RECORD OF DECISION

Pohatcong Valley Groundwater Contamination Superfund Site

Operable Unit 3

United States Environmental Protection Agency
Region 2
New York, New York
September 2016

Figure 2. Simulated TCE Concentration in Groundwater over time at proposed Point of Compliance (6,200 feet downgradient of Area A)

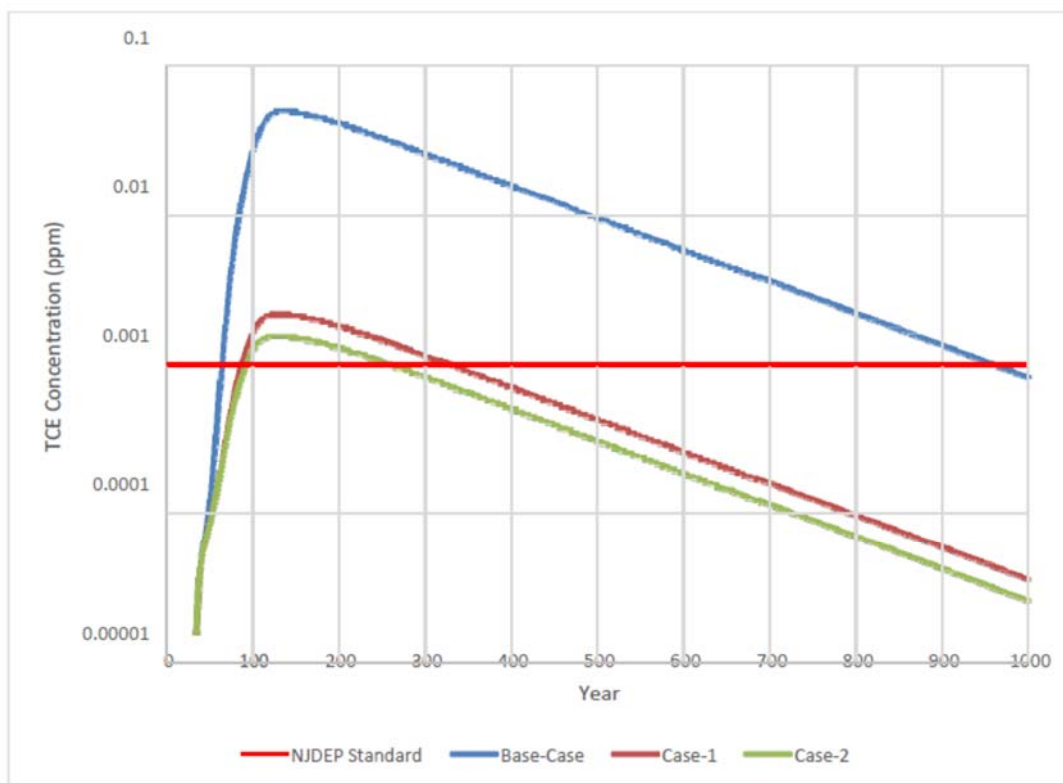
A summary of updated sublayer loads in the simulated scenarios is provided below in **Table 1**. The simulated TCE concentration in groundwater at the modified point of compliance associated with each scenario is compared to the 1 µg/L remediation goal for groundwater and shown below in **Figure 2**.

EPA Response: The commenter utilized the SEVIEW model to demonstrate their modeled treatment zone would be protective of the groundwater aquifer. EPA reviewed the limited results of the modeling presented in Comment 20, including Table 1 (which presents the modeled TCE mass in each sublayer) and Figure 2 (which presents the results of the SEVIEW modeling at a point of compliance located 6,200 feet from the source area). EPA disagrees with this analysis as discussed below. As noted in Appendix C of the FS Report, the SEVIEW software was selected by EPA to support the remediation goal of 1 mg/kg of TCE and to compare various remedial alternatives and the impact they would have on groundwater reaching the OU1 groundwater extraction and treatment system. The SEVIEW modeling was not intended to generate a NJDEP Site-Specific Impact to Ground Water Soil Remediation Standard as defined by NJDEP Remediation Standard Rules (N.J.A.C. 7:26D-1.1) and the NJDEP Technical Requirements for Site Remediation (N.J.A.C. 7:26E-1.3). The SEVIEW model presented by both the commenter and Appendix C of the FS Report does not meet all the requirements in the NJDEP guidance for generating site-specific remediation goals, mostly because the model is not intended for use when a site is capped or when groundwater flows in a fractured bedrock aquifer, as is the case at the Site.

- F) EPA reviewed the evaluation including Table 1 and Figure 2 and generally found that the commenter's approach was much less conservative than EPA's approach. See General Response to this comment above on the intended use of the model. EPA does not agree with the less conservative assumptions presented by the commenter describing the design of the SEVIEW model, including the estimate of the source area size (see response to Comment 20.C above) and the use of a point of compliance 6,200 feet downgradient from the source area (see response to Comment 20.B above). Therefore, the modeling presented in Table 1 and Figure 2 is not a valid approach to model the contaminant source. Specific responses to the bullet items are provided below:

Figure 3.4 Decline in vapor concentrations under diffusion and flow-controlled regimes.

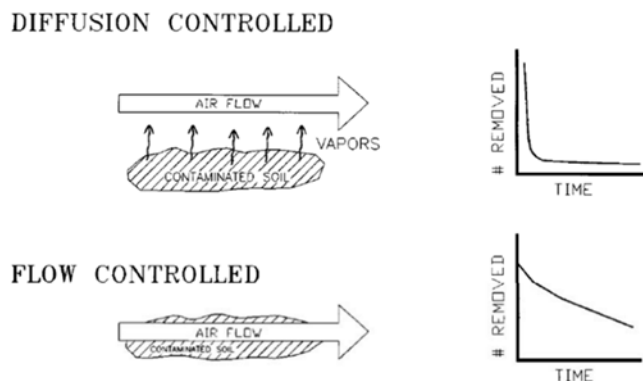
Comment 32: *As for Alternative 4, the preferred alternative, Arcadis recommends forgoing the deep SVE remediation because most of the TCE mass is present in diffusion-limited clays and silts, and because of the heterogeneous nature of Site soils. As per the abundance of published SVE design information available in the literature, SVE is applicable for remediation of soils with high air permeabilities, and much less applicable or even impracticable for the low-permeability silts and clays found at the Site. The issues and limitations of applying SVE in heterogeneous soils, where mass removal rates will be limited by diffusion from low permeability zones has been well understood and studied for many years. Researcher such as M. Truex, G. Beckett, D. Benson, and D. Digiulio have evaluated and documented the effect of diffusion limited mass transfer on the performance of SVE system and the difficulties of attempting to implement SVE systems for heterogeneous sites. The following figures from Suthersan, et al. sum up this*

problem (Suthan Suthersan, "Soil Vapor Extraction", Remediation Engineering: Design Concepts, Boca Raton, CRC Press LLC, 1999):

EPA Response: The commenter recommends forgoing the deep SVE remediation because most of the TCE mass is present in diffusion-limited clays and silts, the heterogeneous nature of Site soils, and mass removal rates will be limited by diffusion from low permeability zones. Review of site boring logs underneath the ANC building indicated the presence of clayey silt, sandy silt and silty sand with trace clay, trace to little gravel and cobbles in the majority of soil volume. Evaluation of grain size distribution indicated that the median grain size is greater than 0.075mm and SVE should be considered. Even though cobble or gravel or sand layers were encountered, they were only found in limited portions of the borings and mostly at depths shallower than 60 feet. Based on the data collected during the RI, EPA believes that the deep SVE system will be effective if properly designed, although it is possible that enhancement technologies may be required. See response to Comment Nos. 2 and 21 for further discussions. A pilot study will be required during the remedial design phase. The pilot study will collect site specific parameters needed for the successful engineering design of a deep SVE treatment system. See response to Comment No. 24 for further discussions.

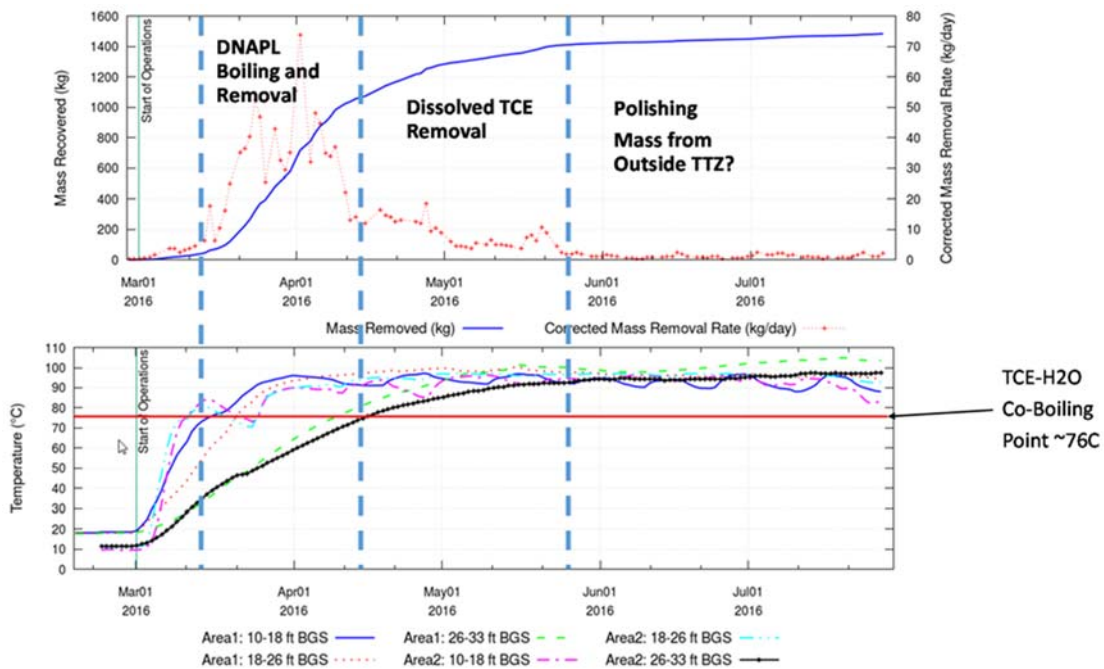
the system should be evaluated with respect to the following lines of evidence. Because collection of confirmatory soil samples at the Site would be very difficult due to access constraints within the ANC building, the following two lines of evidence would be relied upon for evaluation of ISTR treatment system performance:

- f. Heat-up and thoroughness or uniformity of heating within the targeted treatment zone (e.g., 90% of the temperature sensors within the treatment zone achieve 90°C).
- g. Mass removal rates and cumulative mass removed over time. Typically ISTR projects demonstrate a rapid and significant increase in removal rates (e.g., lbs./day of COCs) as significant portions of the site attain critical temperatures such as the co-boiling point of TCE and water (~76°C at 1 atmosphere (ATM)) and the boiling point of water (100°C at 1 ATM), followed by a pronounced decline in removal rates after two to three months of continued heating until the temperature performance criteria are met.

The following figures illustrate the concepts of how the temperature and COC removal lines of evidence are compared to evaluate performance of an ISTR system.

EPA Response: The recommended monitoring can be conducted during the implementation of *in-situ* thermal remediation to monitor the treatment progress, but cannot be used to determine if the remediation goals are met. Post remediation soil sampling will be required to evaluate the effectiveness of the remedy in meeting remediation goals. However, the details of the monitoring requirements will be developed during the remedial design. See response to Comment No. 28 for further discussions.

Figure 2. Simulated TCE Concentration in Groundwater over time at proposed Point of Compliance (6,200 feet downgradient of Area A).

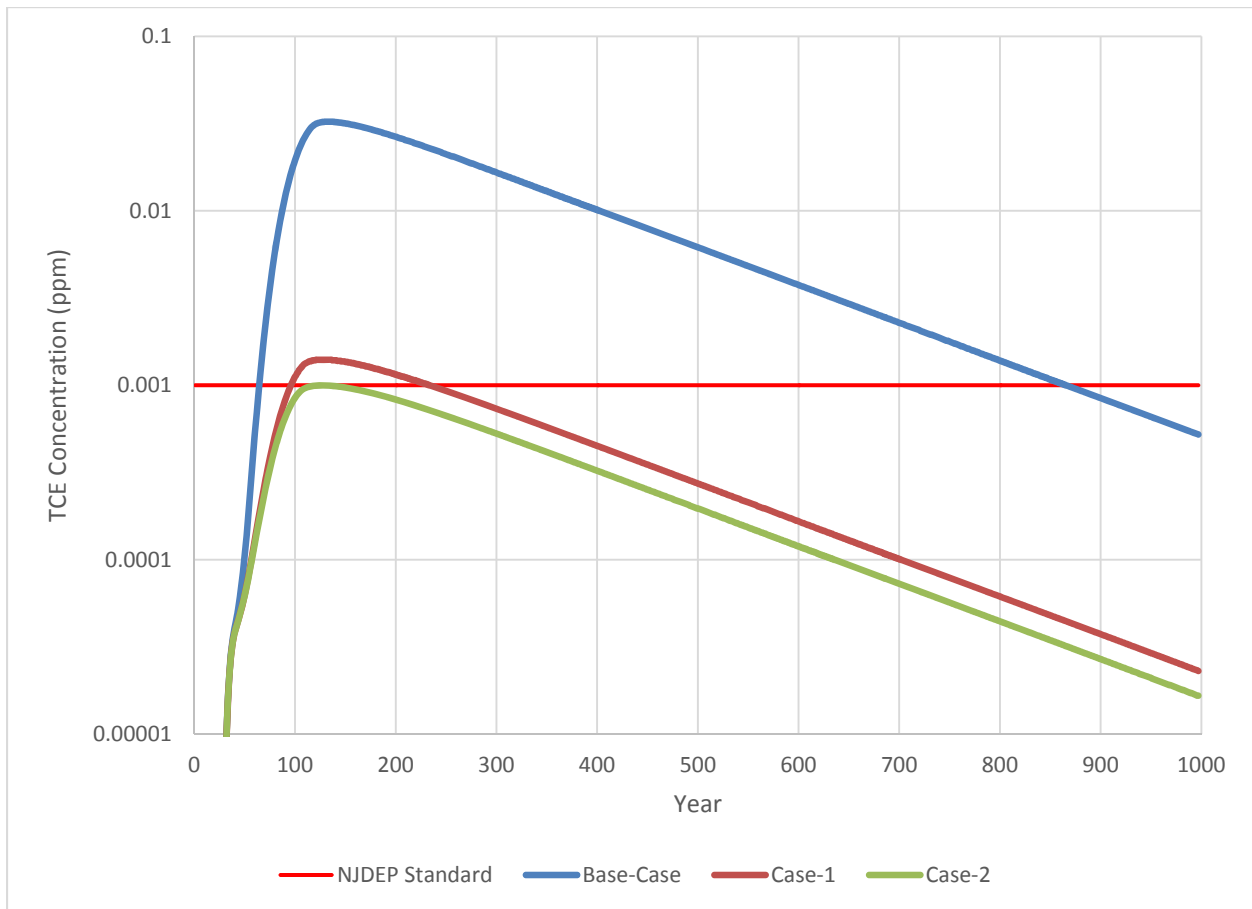
A summary of updated sublayer loads in the simulated scenarios is provided below in Table 1. The simulated TCE concentration in groundwater at the modified point of compliance associated with each scenario is compared to the 1 µg/L remediation goal for groundwater and shown below in Figure 2.

Figure A-3: Illustration of Mass Flux

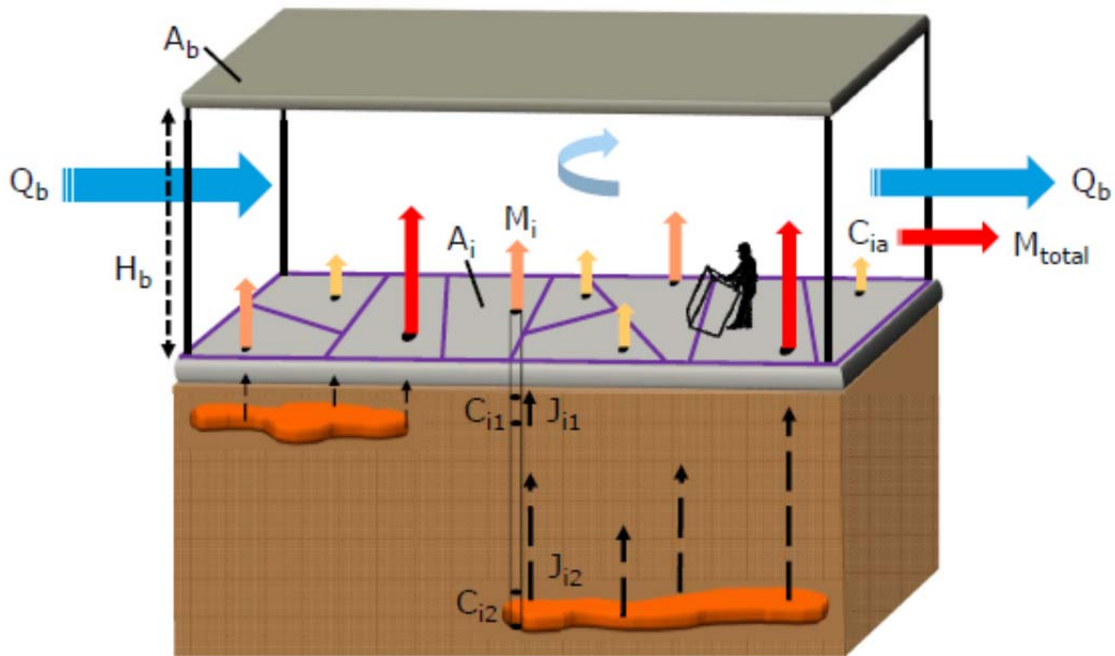
A diagram illustrating these calculations is shown as Figure A-3. The numerical calculations are shown on Table A-2.

**FIGURE
A-1**

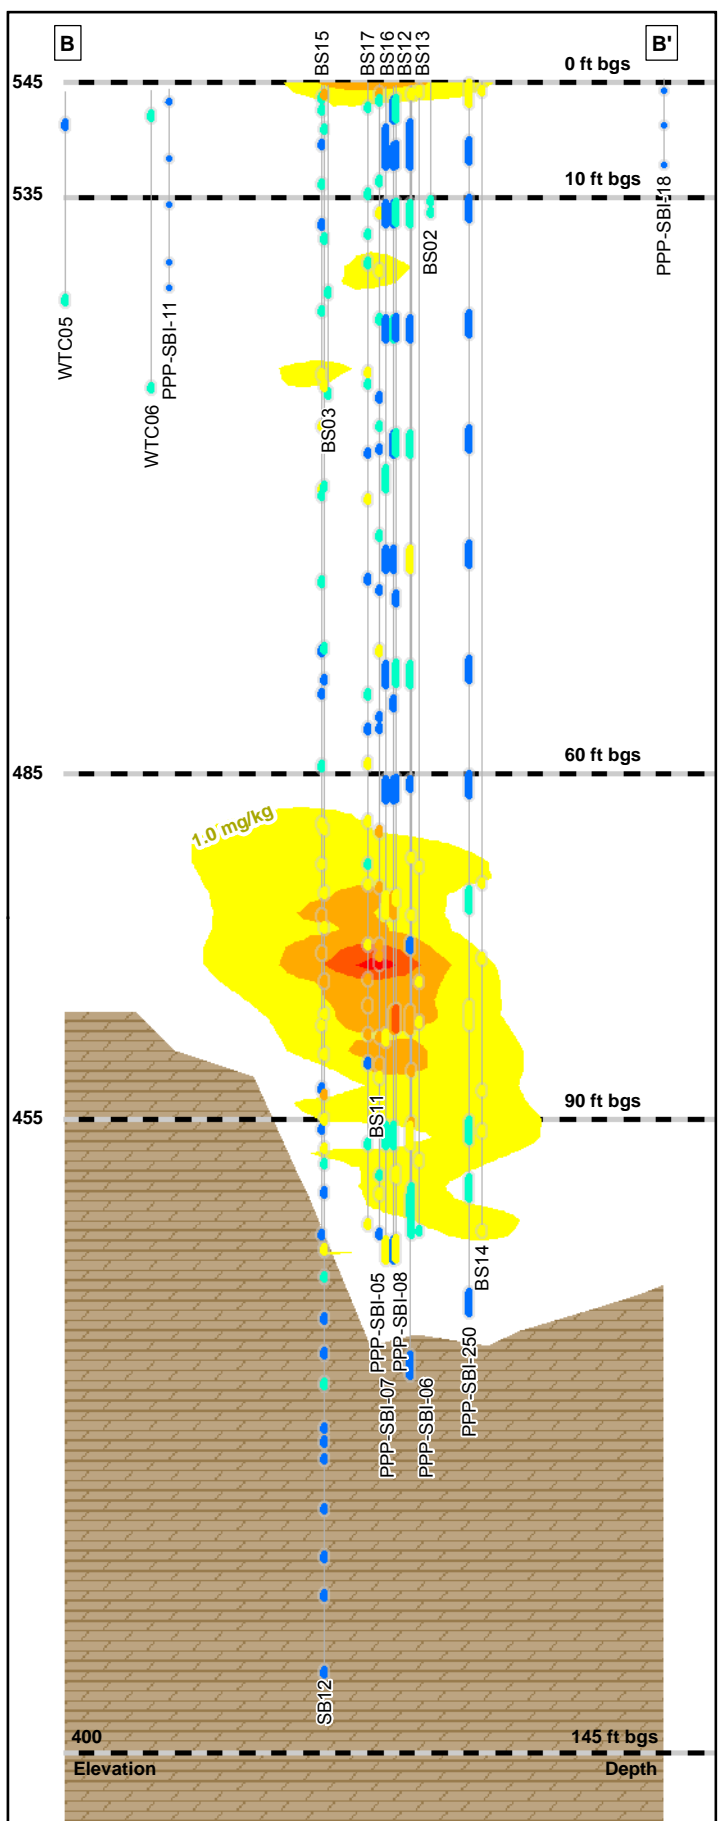
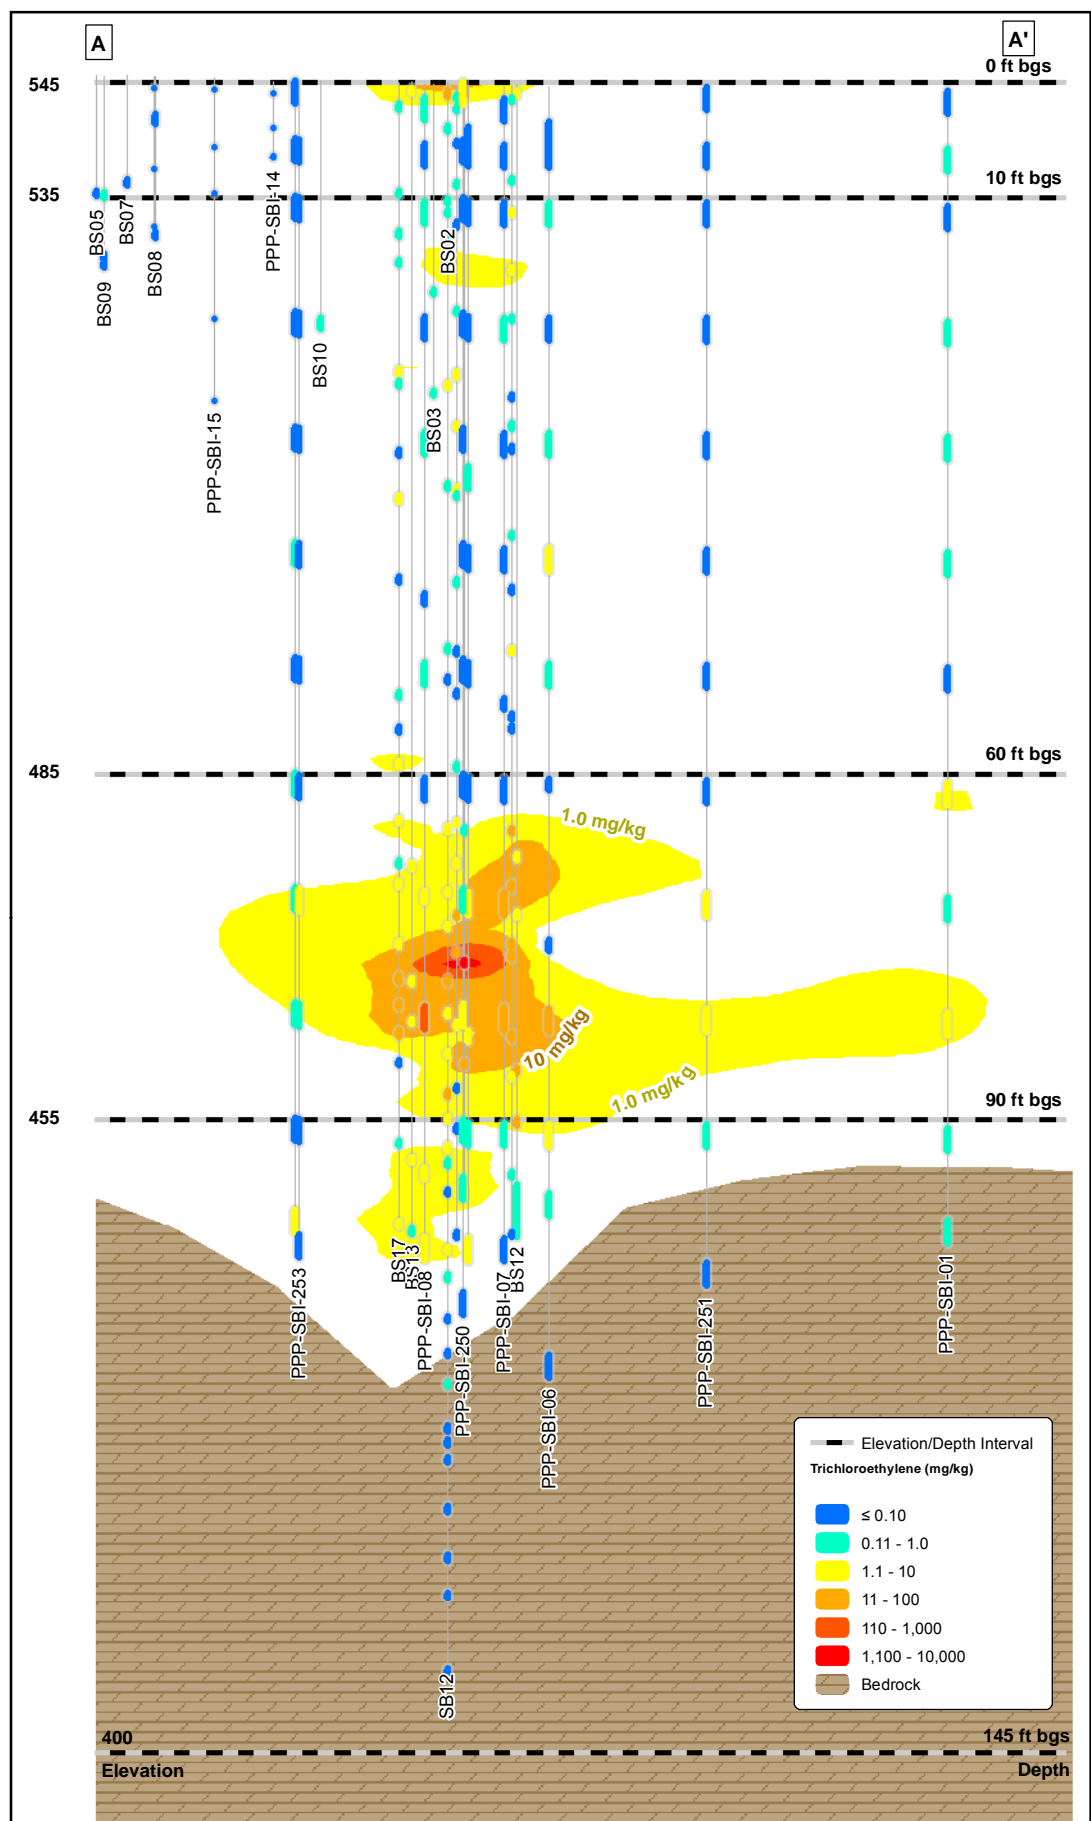
For these calculations, the southwest corner of the ANC building was defined as the exposure area (Figure A-1). This area encompasses the area where subsurface soil TCE concentrations were identified above USEPA's proposed remedial goal of 1 mg/kg. It is also assumed to be an area where workers could have the highest potential for vapor intrusion exposure during the exposure period.
